MFN 06-262
Supplement 4

Subject: **Modified Reactor Building/Fuel Building Truncated Model,
SER-ESB-038 Rev. 5**

**Shimizu Engineering Report SER-ESB-038, Rev. 5,
“Modified RBFB Truncated FE Model Analysis Data,”**

Project	General Electric Company ESBWR Project	Shimizu Document No.	SER-ESB-038
Title	Modified RBFB Truncated FE Model Analysis Data	Rev.	5
		Issued Date	9/22/06
		Revised Date	1/9/07

Figure C-33 Element Forces Comparison NASTRAN to ANSYS (Basemat Section B-B: Axial Force [MN/m])

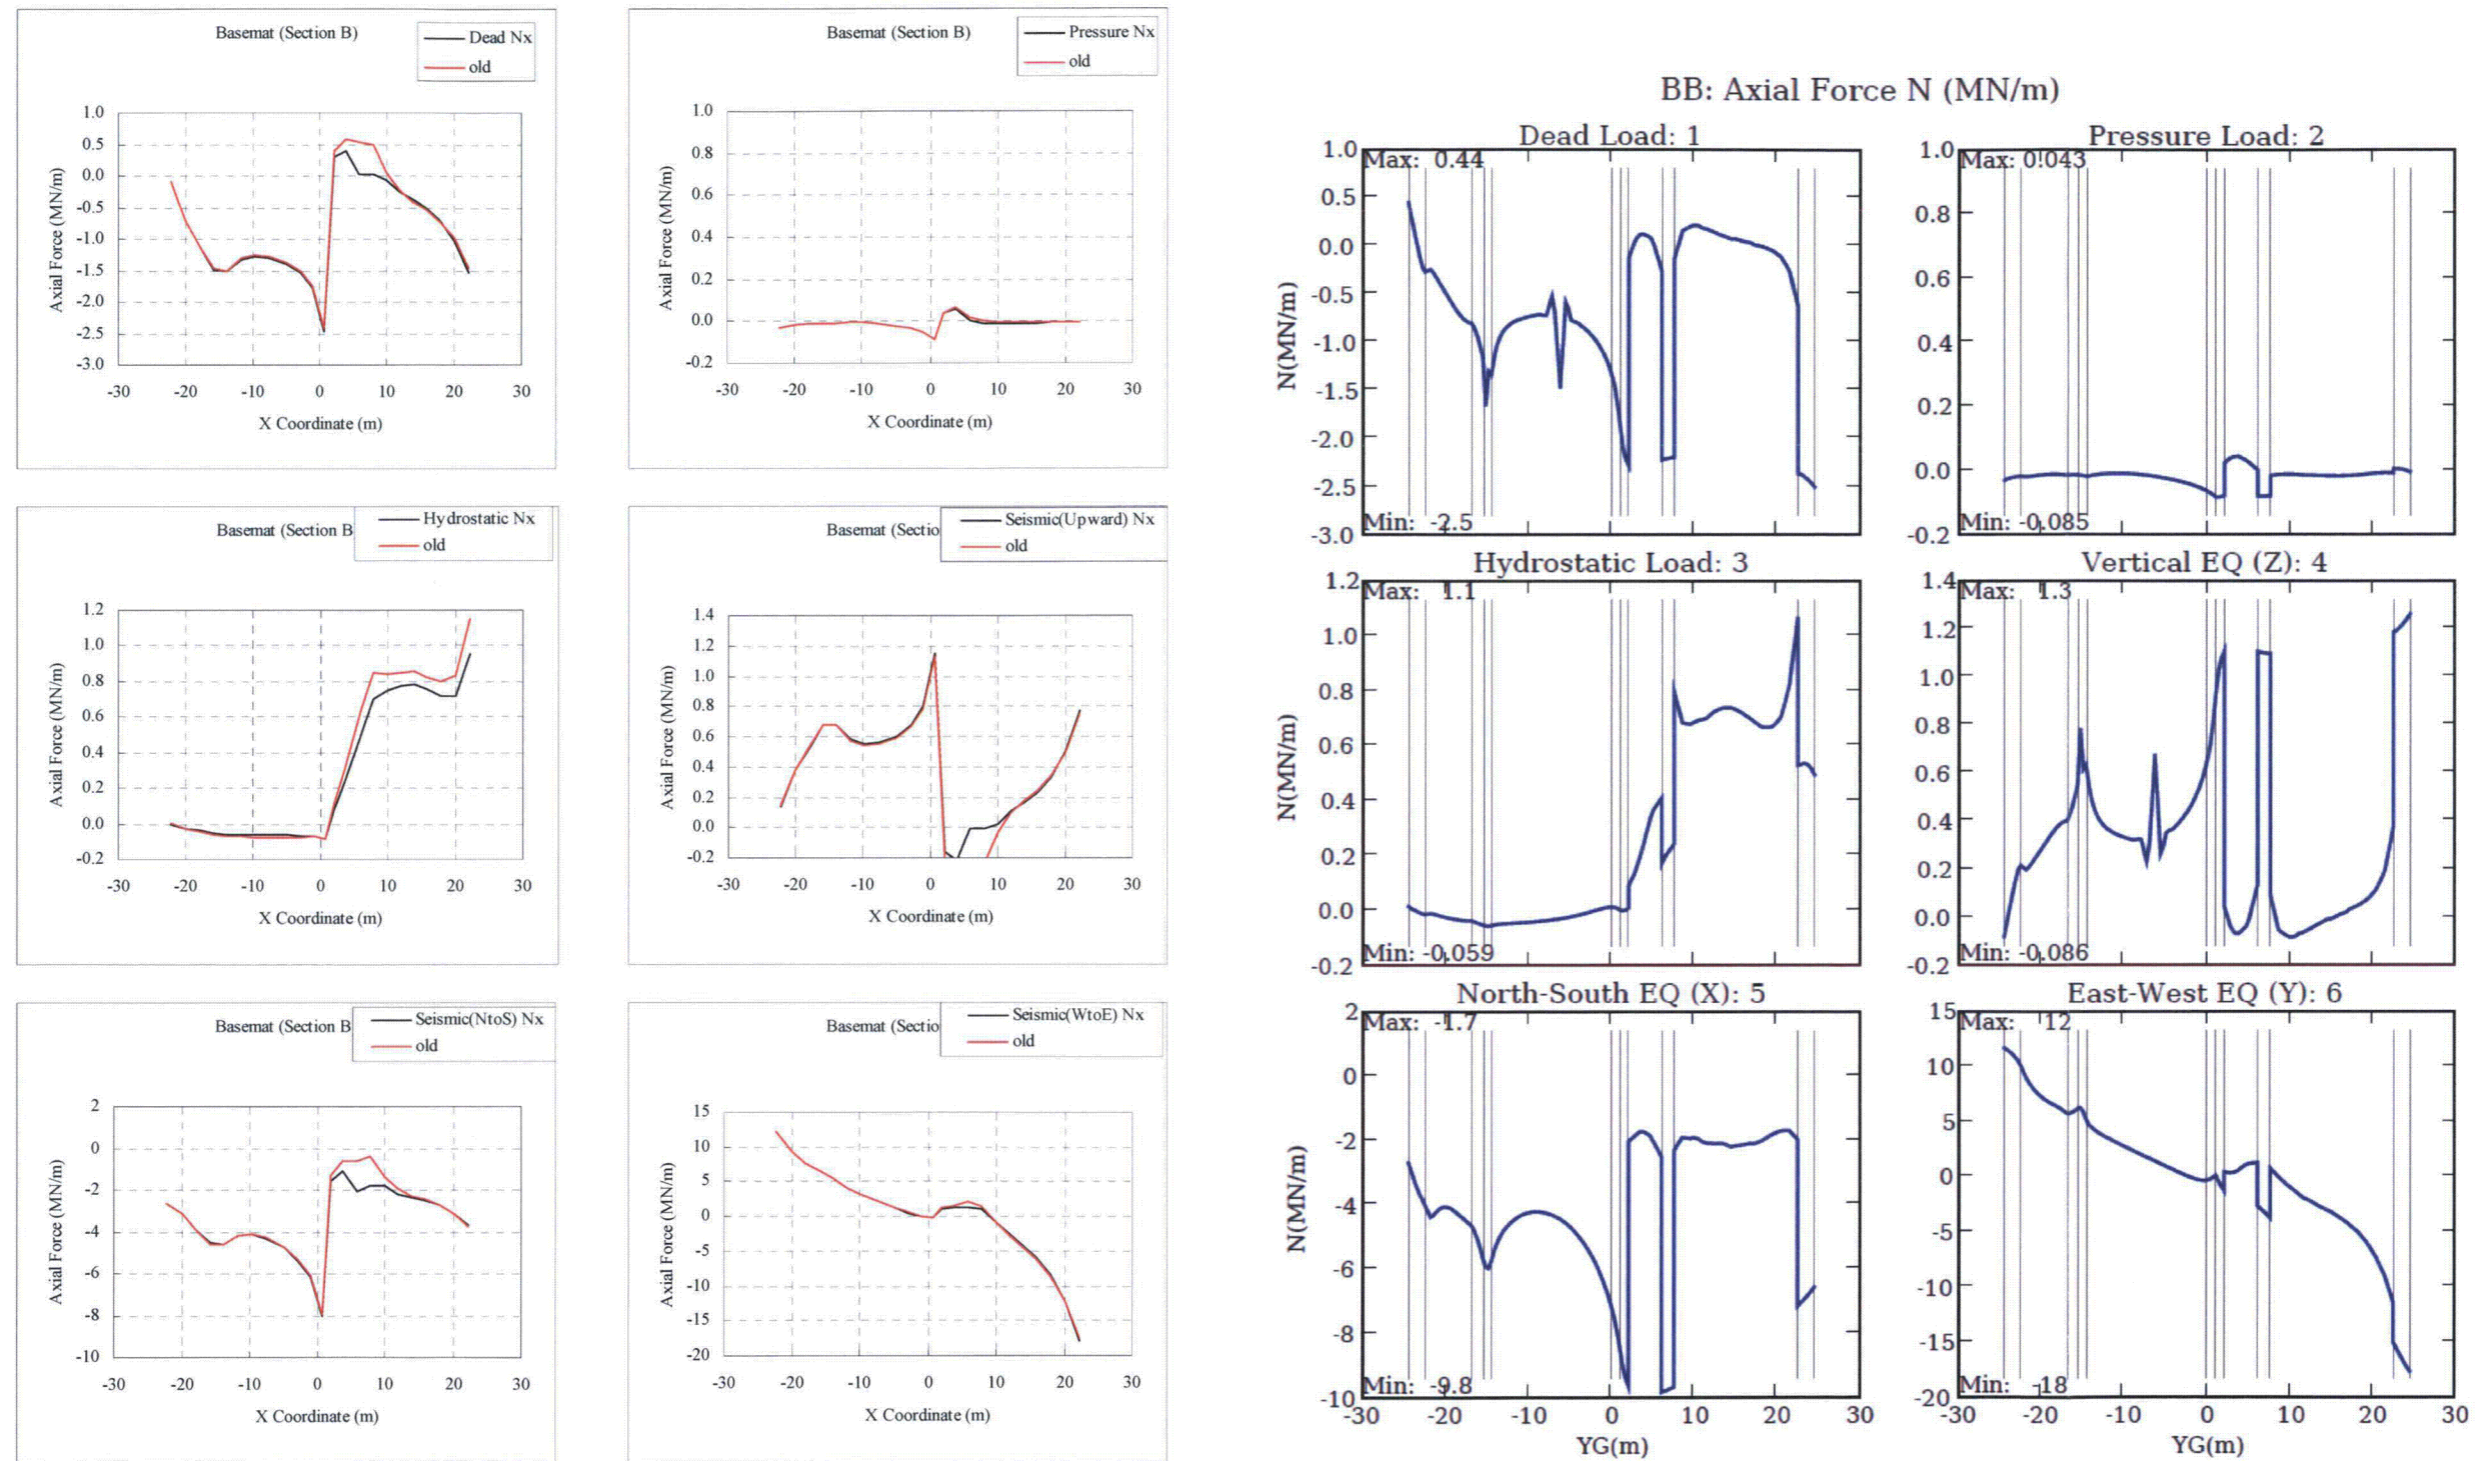
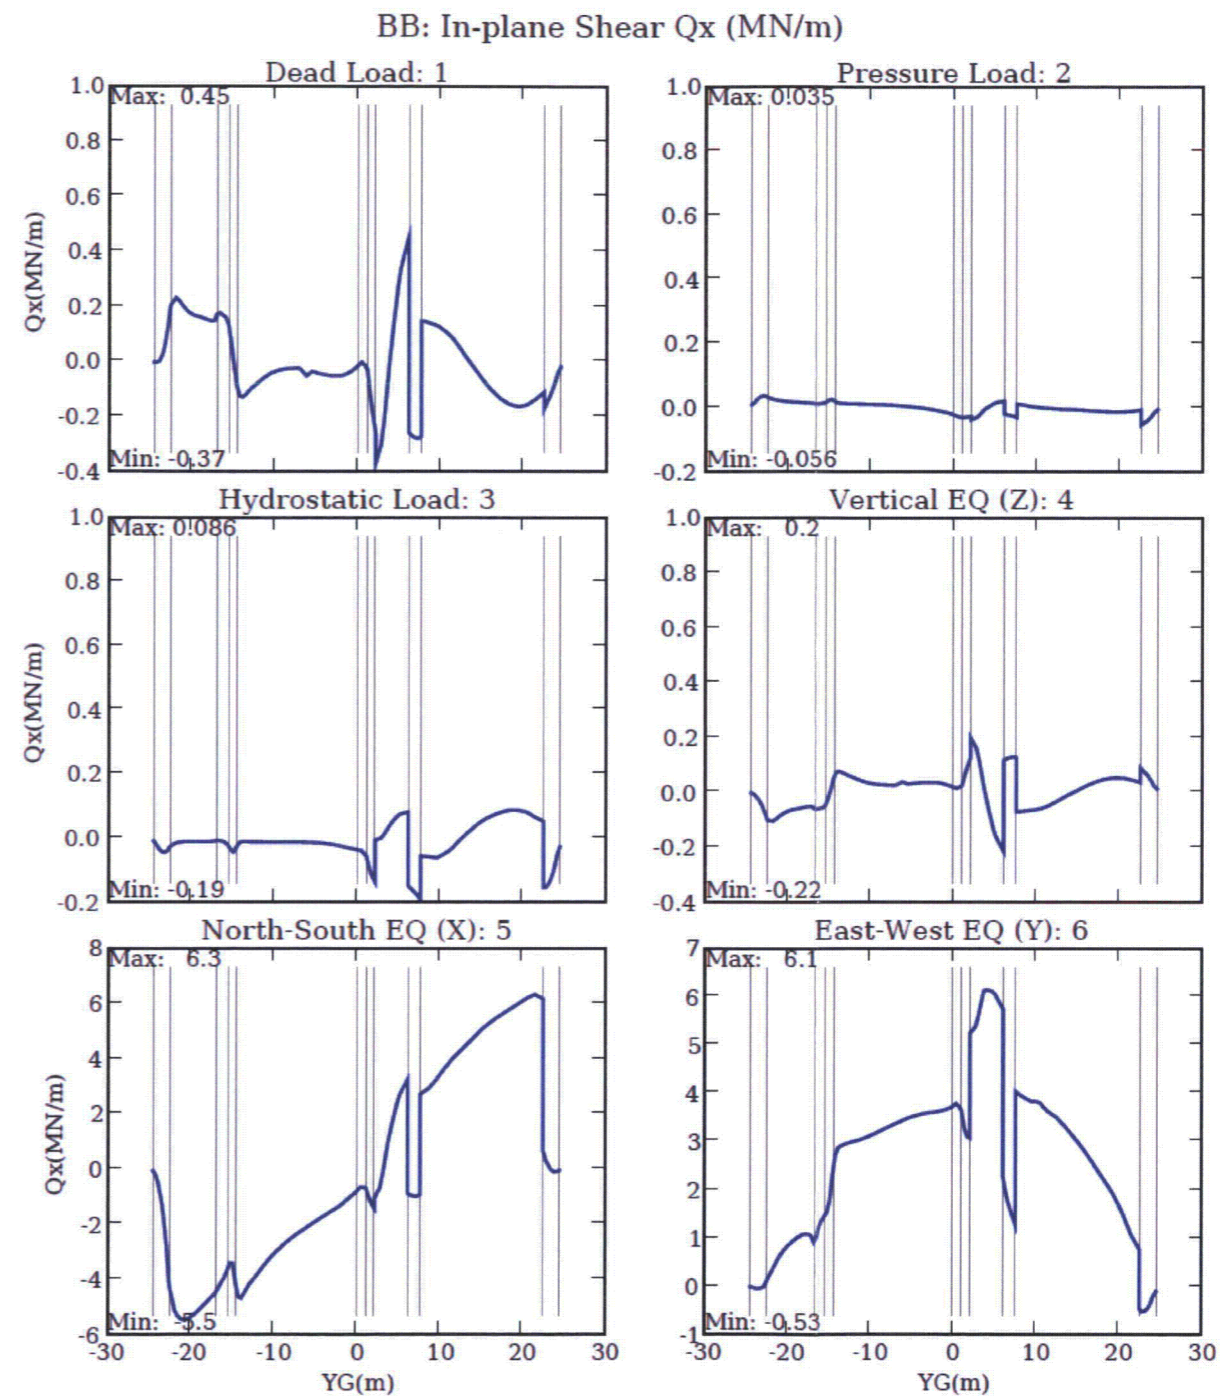
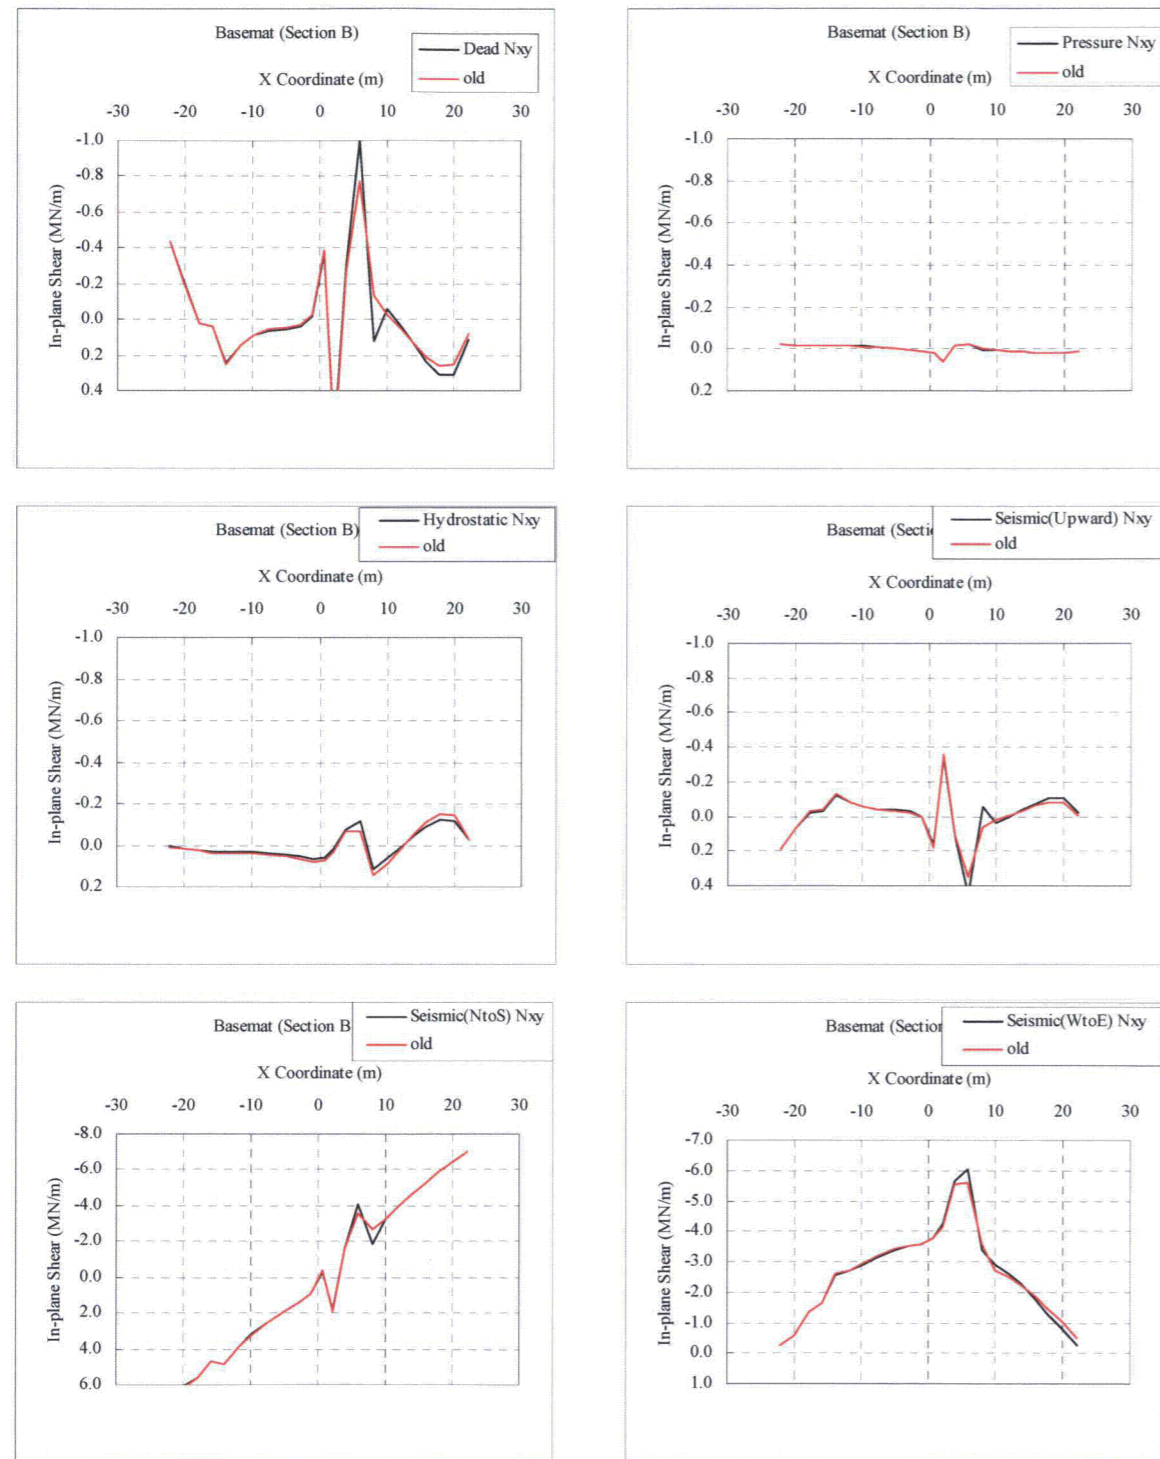
- iii) *The differences of magnitude of forces appeared on basemat inside pedestal:* The result of re-analysis using the updated model shows better agreement. In case of seismic load the magnitude of forces has to be re-compared because BNL's soil spring may not be adequate as pointed out above 3).

- iv) *The differences of magnitude of forces appeared on outer wall of Fuel Storage Pool (FSP):* For the out-of-plane shear forces and moments on RA and F3 wall located around FSP in case of Hydrostatic load, BNL's results are lower than those of GE. GE assumes the some part of differences comes from the difference of estimation levels between both models as pointed out above 8). In order to have a better understanding of the differences, GE would like to request BNL to confirm the input data for Hydrostatic load.
